MIL-STD-1325-175 (NAVY)
Change Notice 1
5 November 1975

RAILCAR LOADING OF HAZARDOUS MATERIALS

BOMB, 2000 LB. MK 84 MOD 3 (THERMALLY PROTECTED) IN UNIT LOAD ADAPTER MK 79 MOD 0 WITH SADDLES FLEET ISSUE UNIT LOAD

TO ALL HOLDERS OF MIL-STD-1325-175 (NAVY)

Page 2

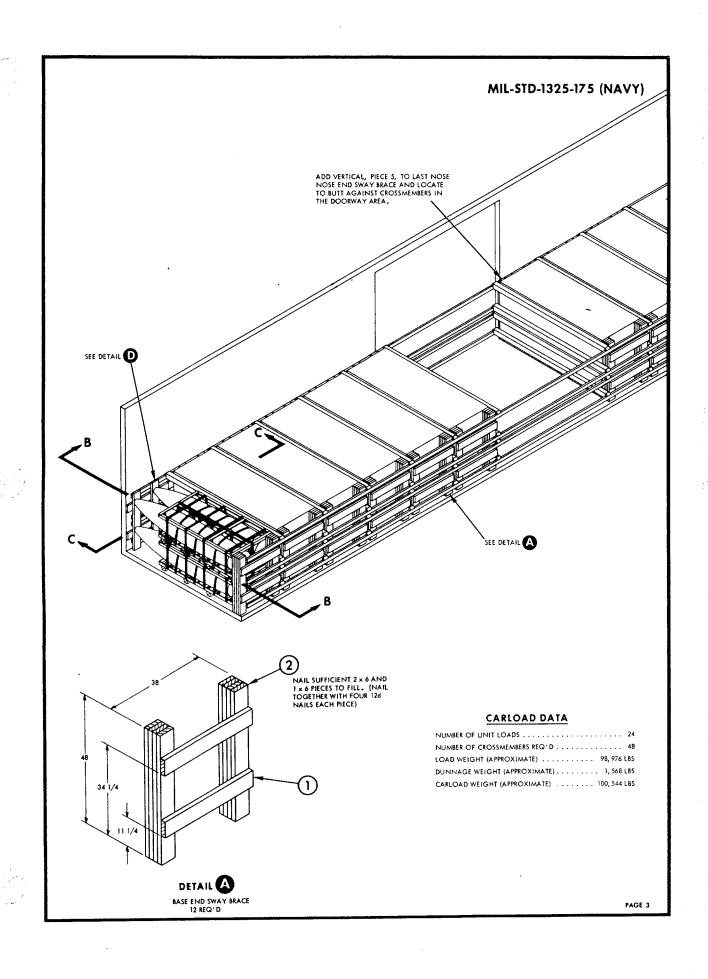
1. Add to NOTE 3 "and with door openings not less than 9 Ft."

Page 6

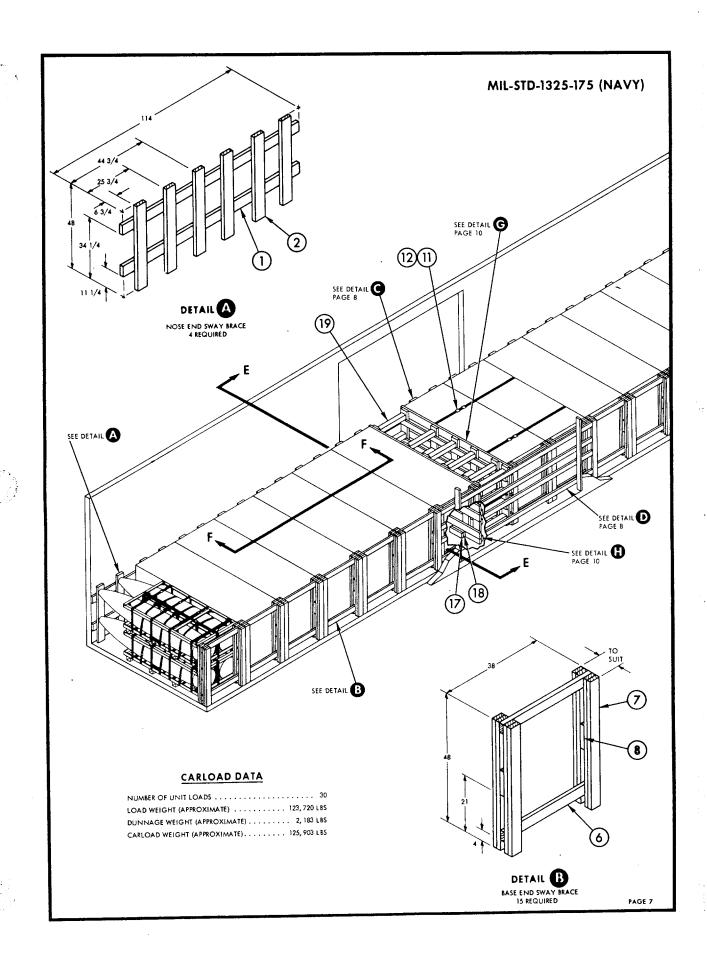
- 1. Change NOTE 2 to read "When less than carload (LCL) quantities are required to be shipped in commercial boxcars and a partial layer results, the partial layer of lading shall be braced by means of end bracing and/or partial layer bracing constructed in accordance with MIL-STD-1325-100 (NAVY) or partial upper layer bracing in accordance with MIL-STD-1325-102 (NAVY). Select the type of brace to comply with the weight of the units to be retained. The weight distribution requirements of the AAR must be complied with, see MIL-STD-1325 (NAVY)."
- 2. Change the second sentence of NOTE 3 to read "The depicted procedures and methods of blocking are applicable to boxcars equipped with conventional sliding type doors other than 10 Ft. wide, but not less than 9 Ft. wide, providing the length of pieces 3 and 10 are adjusted as required to suit the particular doorway opening."
